TECHNICAL SERVICE BULLETIN

Technical Service Bulletin: 53-1303

TECHNICAL SERVICE BULLETIN 53-1303 REMEDY INSTRUCTIONS

Make(s): Shasta Oasis Model(s): SST20RB Model Year(s): 2021	Repair Code: SB-657-03-00-003995 Allotted Time: .25 hrs. Inspection Code: N/A Allotted Time: N/A
	Concern: The installation of the optional LP/Electric refrigerator is located too close in proximity to the water heater and the heat from the water heater exhaust has the potential to cause deformation to the refrigerator vent.	Photo(s) Required: No Prior Authorization Required: No Part(s) Number: N/A Part(s) Return: No

Figure 1

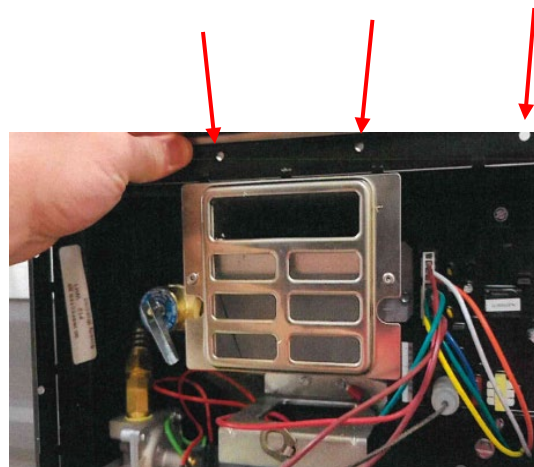
The water heater exhaust is too close to the refrigerator access door and excessive heat could cause the refrigerator access door to melt.

1. Make sure the water heater is disabled and the exhaust plate is cool to the touch.
2. Remove the Dometic water heater access door.
3. Remove securement OEM fasteners from the top of the water heater and place aside to reuse. Figure 1.
4. Carefully fold the top black flange of the water heater outward approximately 1/4" to 3/8".
5. Apply appropriate butyl tape or sealant to rear of the provided heat deflector covering the deflector's screw holes. Figure 2.
6. Insert heat deflector between black flange of the water heater and the sidewall. Make sure to center it over the exhaust plate with the holes aligned with the factory mounting holes. Figure 3.
7. Bend the black flange of the water heater back against the sidewall and reinstall OEM fasteners.
8. Reinstall water heater access door.
